**CHEMICAL ENGINEERING
PROCESS DESIGN AND ECONOMICS**

Web References

Alkylate Splitter Module Simulation Calculations

Figure 1: Simulator-generated "flowsheet" for alylate splitter module.

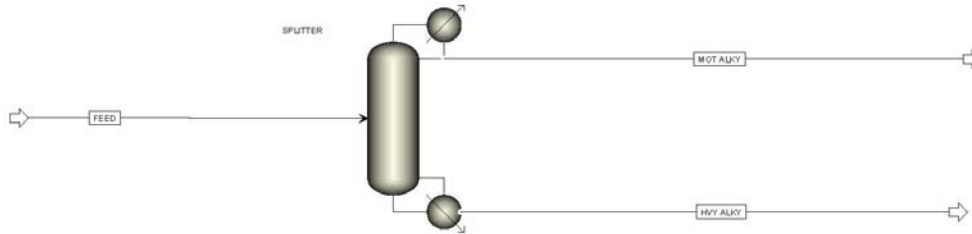
Ulrich: Is possible to get a single comprehensive flow sheet/streamchart document from the software?

Vasudevan: I was able to print out the document attached (see Figure 1). It is theoretically possible to include heat exchangers, pumps, etc, but this can be a nightmare. Convergence becomes a major headache because of problems with tear streams. Unless the right tear stream is chosen, convergence is not easy. I am still struggling with this.
